FrutaMIDI: capacitive USB MIDI controller

Engineering report

FrutaMIDI v1.2 (change request CR-002), interfaces frozen-4, 2026-11-07

Prepared for release V1.2 (git tag `v1.2.0`); not yet released. Previous release: V1_BASELINE (git tag `v1.1.0-baseline`)

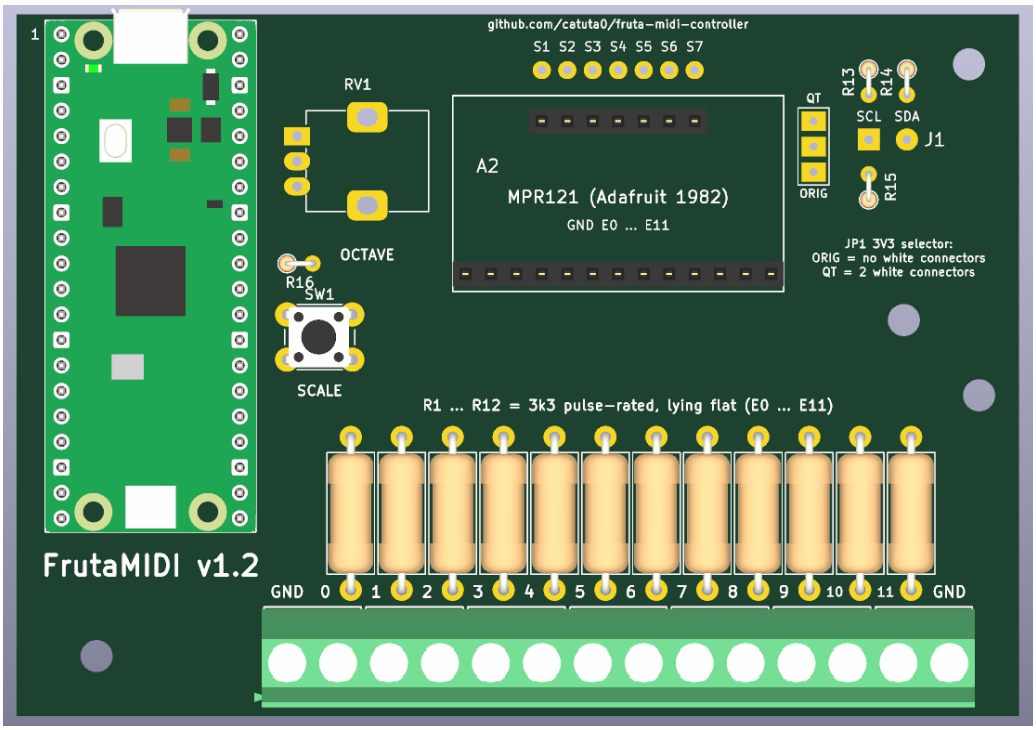
End caps on the component side (T-073, finding C2-002). The closest metal of a flat resistor is cap to cap, not copper to copper. The Vishay drawing gives no cap length, so it is swept: cap length L_c 1.5–3.5 mm (ASSUMPTION), body length 11.9 mm (SOURCE, $L_{\max}$) and 11.0 mm (ASSUMPTION, no $L_{\min}$ given), cap diameter 4.2 mm (SOURCE), lacquer ignored, axial placement error of a hand-fitted body 0 / ±0.25 / ±0.5 mm (ASSUMPTION). Same channel the gap is $L - 2L_c$; the cross-channel pair (E cap of Rk to ELE cap of R$k \pm 1$) is the worst (CALCULATION, `check_gap.out` section (d)):

Highlights. The closest metal of a flat resistor is its end caps, not the copper (C2-002): the 8 kV gap claims now apply to copper only, and the 4 kV end-cap result is PARTIAL on an assumed cap length (Section 5.5). The pulse energy had been overstated about twice (C2-003): 182 mJ, not 364 mJ, with the verdicts unchanged. A metal screw at the old H3 position could bypass R12 (1.94 mm bypass sum, FAIL); H3 moved to (96, 38) mm (15.36 mm, PASS) (CALCULATION, `check_gap.out`).

Layout (v1.2). R1–R12 lie flat in one row with their axis along y, 15.24 mm lead pitch (datasheet minimum 15.0 mm, SOURCE EE-S17b), pads 2.2 mm, drill 1.1 mm since T-073 (was 1.0 mm; finding C2-008): annular ring $(2.2 - 1.1)/2 = 0.55$ mm ≥ 0.40 mm and hole − lead = 0.30 mm diametral ≥ 0.2 mm for the 0.8 mm lead (CALCULATION; `calc_mechanical.out` "R_Axial_DIN0414... 1.10 2.20 24 0.55 0.80 0.30 PASS"). The ELE fan-out runs at 45° above the row and the E side runs straight to J2 (Figures 1 and 2). To make room, the MPR121 module moved 15.1 mm up and 2.54 mm right; J1, JP1 (now upright) and R13–R15 moved to the right of the module; H4 moved from (70, 6) to (88.5, 30.5) mm; in T-073 H3 moved from (95,
